Product Change Notice (PCN)

PCN Number: PCN-0450216R-01

Product(s) Affected: MD-SV series (part numbers MD-30SV, MD-40SV, MD-50SV, MD-60SV, MD-70SV, MD-80SV).

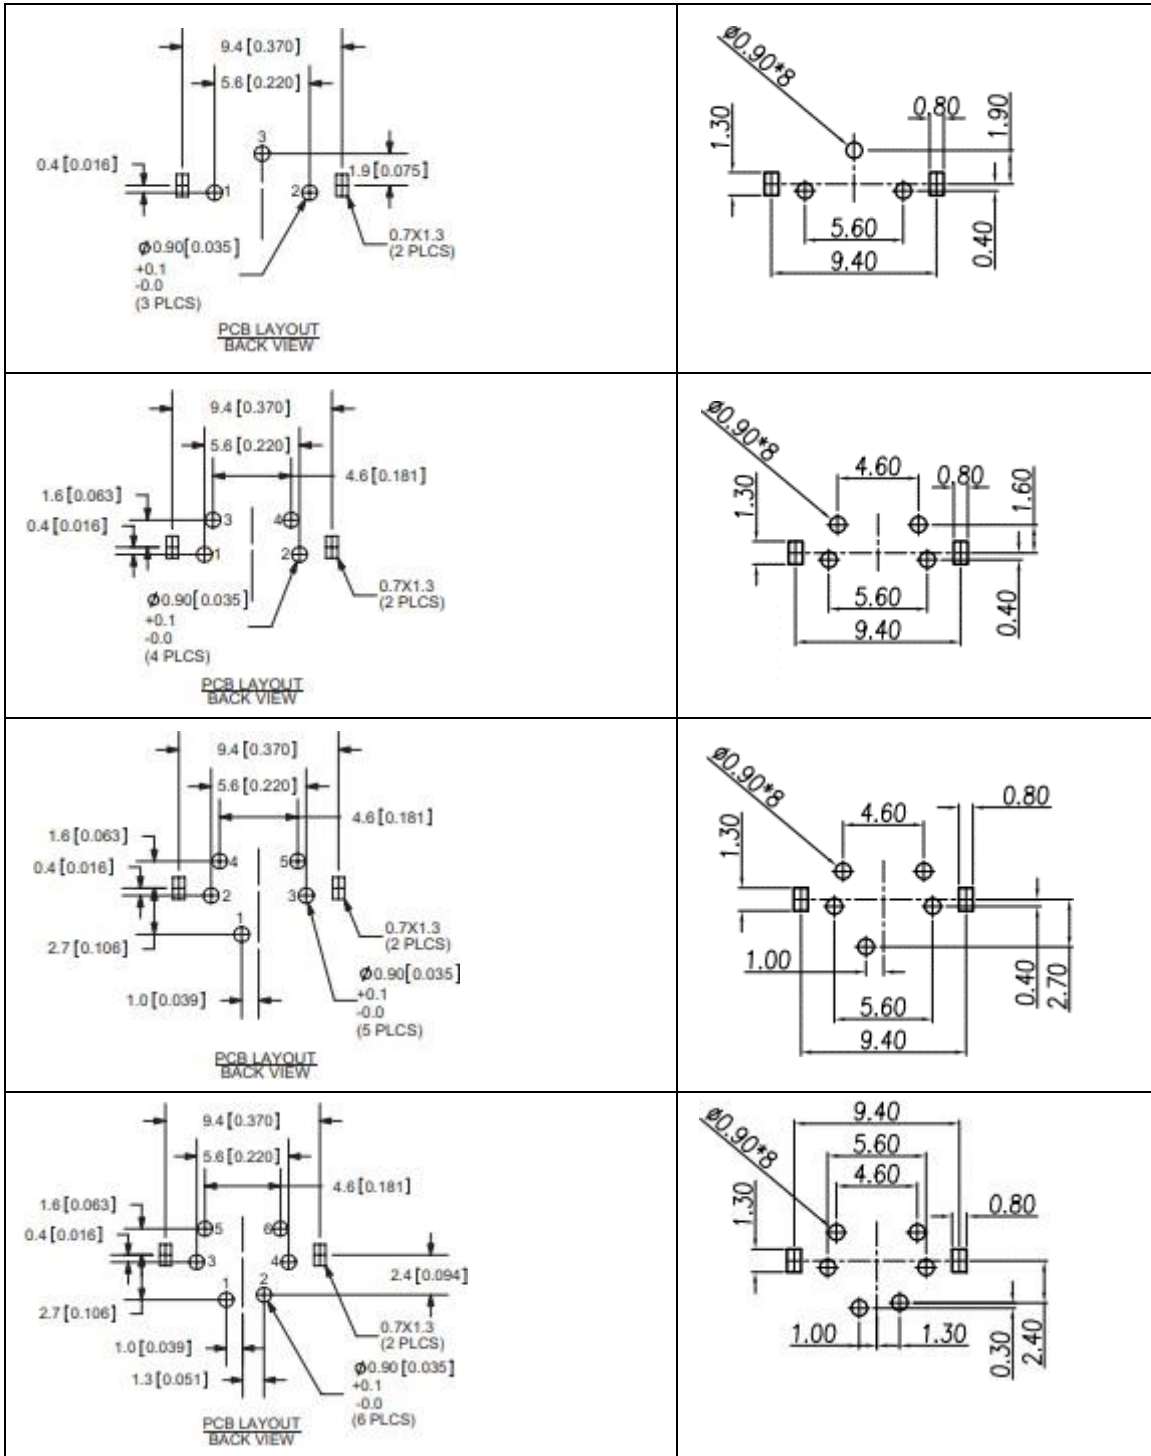
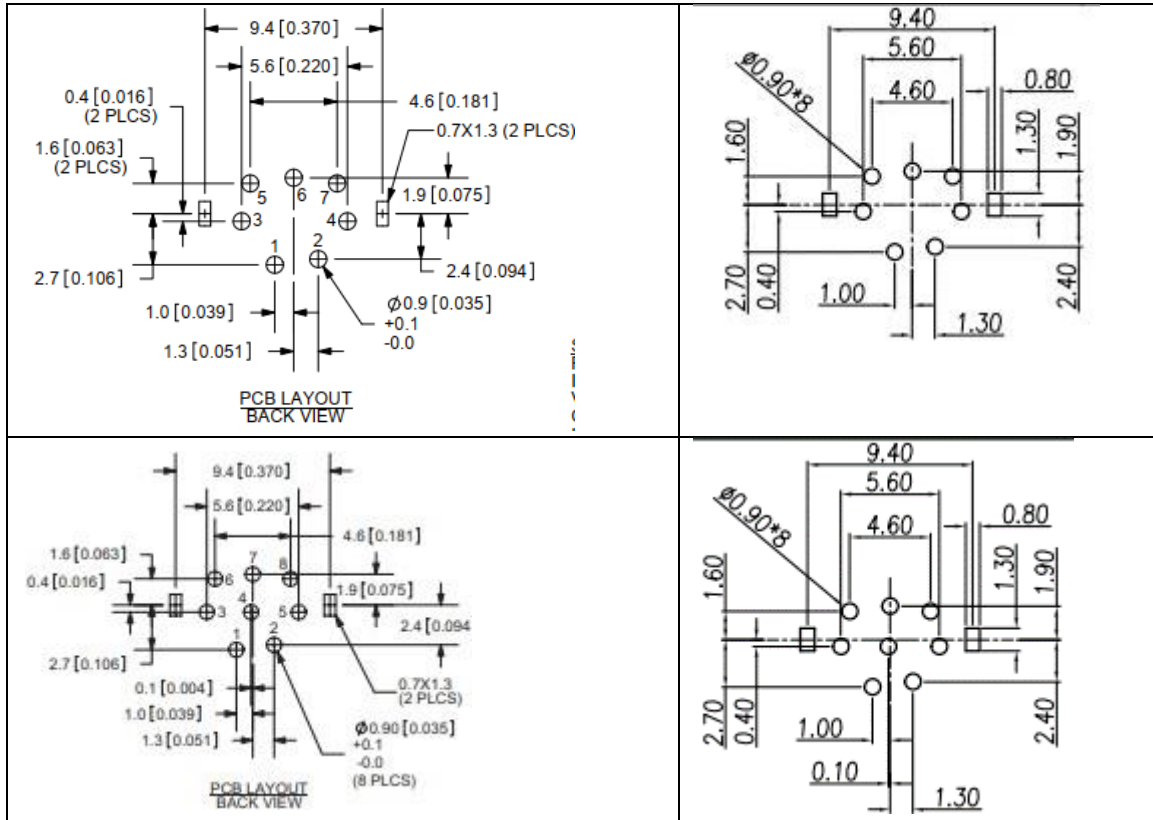
Description of Change: minor dimensional changes, such as pin length, and materials changes as shown below.

Old design materials

MATERIAL	PLATING
earth terminal	brass	tin
contact terminals (1~8)	phosphor bronze	silver
plastic	PBT

New design materials

MATERIAL	PLATING/COLOR
housing	PBT (UL94V-0)	black
contacts	phosphor bronze	tin
shell	brass	nickel
